ZEE Systems, Inc.

SERVICE LETTER 47-003-1

2.0 PURPOSE: These motors have dual shafts. This letter provides instructions to make a one shaft motor from the dual shaft motor in the field. The evaporator has two blowers, the SZ47-003-2A Blower requires a motor that turns clockwise (CW) and the SZ47-003-1A motor requires a motor that turns counter-clockwise (CCW). Providing a motor with dual shafts, one side turning CW and the other turning CCW, allows spares to stock only one motor for either application. Rotation of the motor is determined by looking at the shaft to be used.

FIG. 1

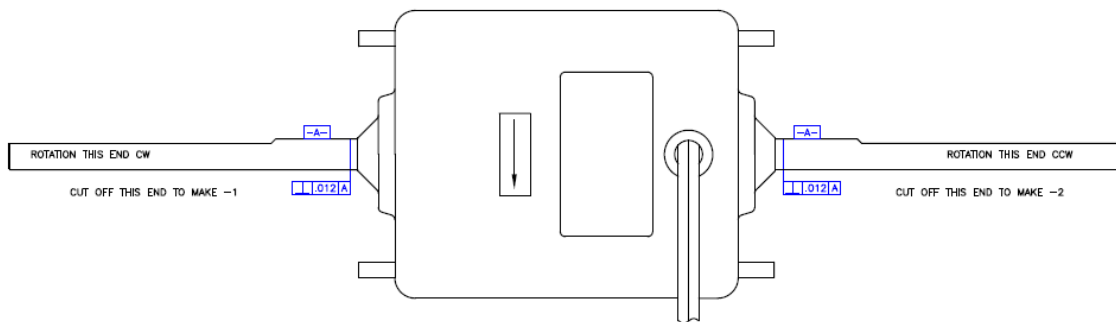
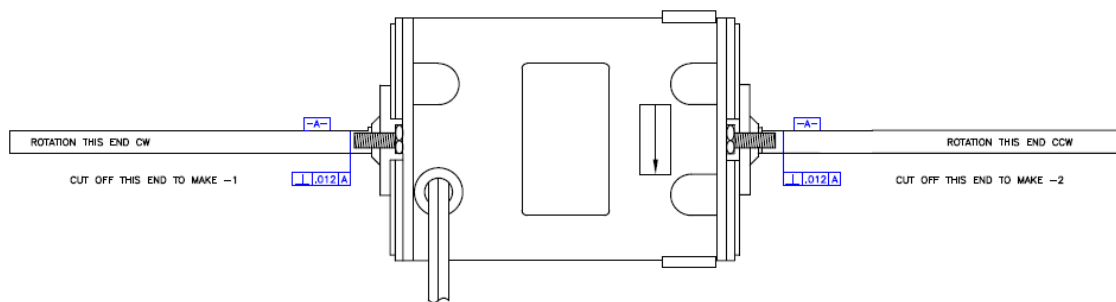
Cut off the opposite motor shaft as close to the housing as possible. Take precautions to insure that metal shavings do not contaminate the inside of the motor. See FIG. 1.
